PZ&B Combination Staff Combination Memorandum: Architectural Commission and Town Council

SUBJECT: ARC-23-146 (ZON-23-119) 995 S OCEAN BLVD

MEETING: DECEMBER 15, 2023 ARCOM  
JANUARY 10, 2024 TC

**ARC-23-146 (ZON-23-119) 995 S OCEAN BLVD.** The applicant, Mary S. Conrad, has filed an application requesting Architectural Commission review and approval of a second story addition requiring variances to build within the required setbacks. This is a combination project that shall also be reviewed by Town Council as it pertains to zoning relief/approval.

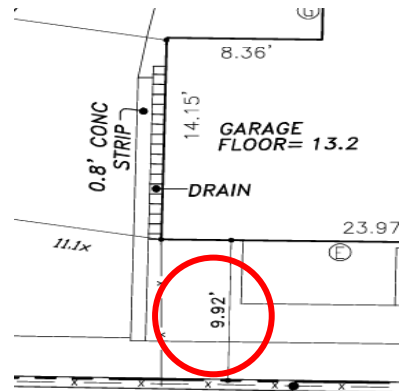
The applicant is seeking to add a second floor to the one-story garage. In order to do so, variances are required to further encroach on the front yard setback. The variance would be to (revest) reduce the front yard setback at the first floor varying from 18.67 to 21.08 where 35' is required (**variance #1**) and to reduce the front yard setback at the second floor varying from 27' where 35 is required (**variance #2**). The applicant has designed the second floor to be further setback from the street.

Both variances reflect the greater relief distance as the right of way is at an angle to the structure placement on the lot. The second-floor addition will contain approximately 215 SF of enclosed space and be utilized as an art studio to be added above an existing one-story area. Both the building height and the overall building height will be lower than the existing 2-story areas. The existing flat roof of the garage will be removed and a sloped roof with a lower eave line will replace it.

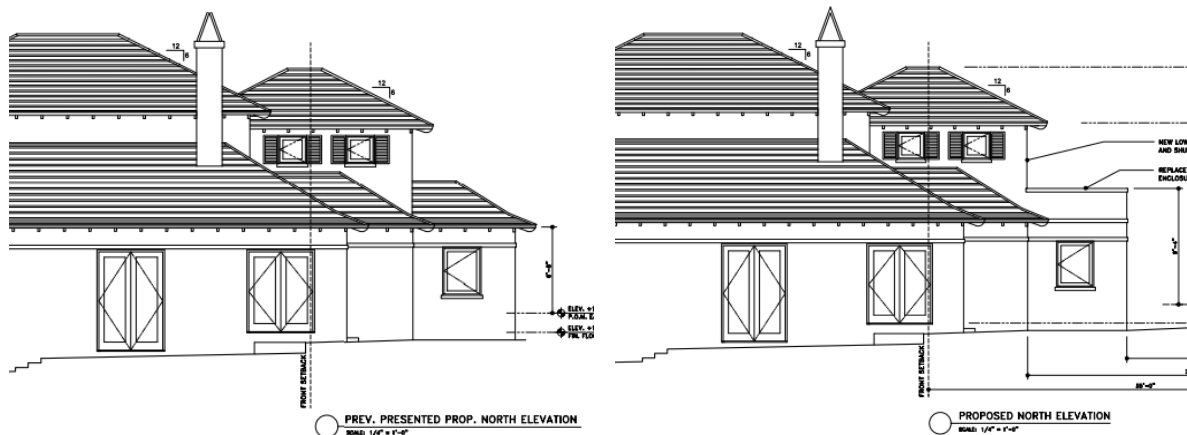
In addition, due to the nonconforming setbacks and siting of the structure built in 1950, the proposed second floor addition does not comply with the building height plan requirements in its two locations (**variance #4**).

Following comments from ARCOM the applicant has resubmitted with a change in the lower roof line of the garage. The existing flat roof of the garage will be removed and a terrace will replace it. Although variances are still required for the addition the slopped roof has been modified to a flat roof over the existing garage. The proposed addition has been designed sensitively as it pertains to the existing 1950s structure.
